APPLICATION NO.	FILING DATE	FIRST NAMED INVENTOR	ATTORNEY DOCKET NO.	CONFIRMATION NO.
10/804,049	03/19/2004	Kuo-Chen Liu		6942

Office Action Summary	Application No. 10/804,049	Applicant(s) LIU, KUO-CHEN	
	Examiner Hadi Shakeri	Art Unit 3723

DETAILED ACTION

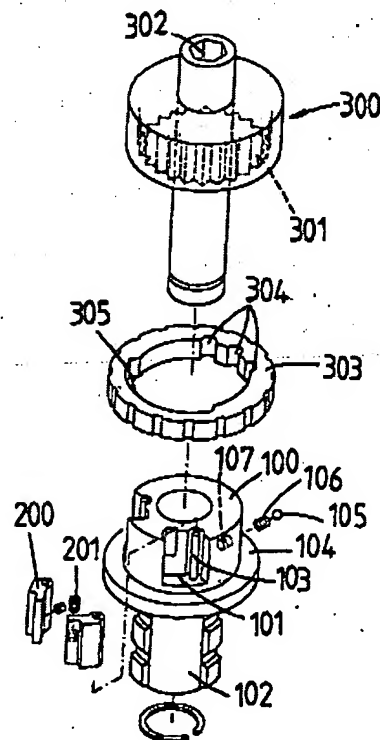
1. The disclosure is objected to because of the following informalities: on page 5, slot "26" should be changed to slot "36".

Appropriate correction is required.

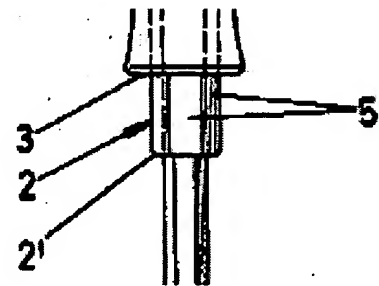
As admitted by Applicant, e.g., pages 1 and 2, and Figures 9 and 10, the ratchet wrench of prior art meets all of the limitations of claim 1, except for the recesses to have holes receiving the shafts of the pawls, since the connection is made by a shaft (103) in the recess to engage a hole (not numbered) in the pawl. It would have been obvious to one having ordinary skill in the art at the time the invention was made to place the hole in the recess engaging a protrusion of the shaft of the pawl, in reducing the manufacturing cost, since it has been held that a mere reversal of the essential working parts of a device involves only routine skill in the art. *In re Einstein*, 8 USPQ 167.

Regarding claim 3, AAPA as modified meets the limitations, i.e., engaging recess (302).

Regarding claim 2, AAPA as modified meets the limitations, except for the engaging top to have a polygonal contour, since it is intended and designed as a socket wrench, however, it would have been obvious to one having ordinary skill in the art at the time the invention was made to make the outer surface polygonal to engage a workpiece internally, e.g., as an Allen wrench, since it has been held that changing shape, dependent on work-piece parameters, involves only routine skill in the art. *In re Stevens*, 101 US PQ 284(CCPA1954).

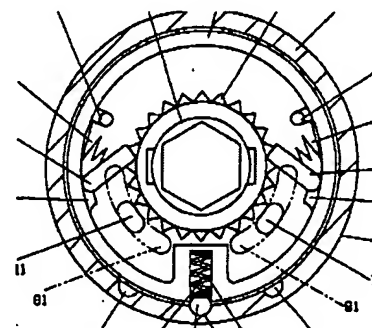
AAPA as modified above meets all of the limitations of claim 4, except for the protrusion (121) engaging a slot (36) in the ring. Hu teaches screwdrivers in which a post (711) engages

a slot in a ring. It would have been obvious to one having ordinary skill in the art at the time the invention was made to modify the invention of AAPA with polygonally shaped engaging top as taught by Hu for steadying the parts during relative movements, with regards to location of parts, it is noted that it would have been obvious to one having ordinary skill in the art at the time the invention was made to place the post on the flange engaging the slot in the ring (303), since it has been held that rearranging parts of an invention involves only routine skill in the art. *In re Japikes*, 86 USPQ 70.
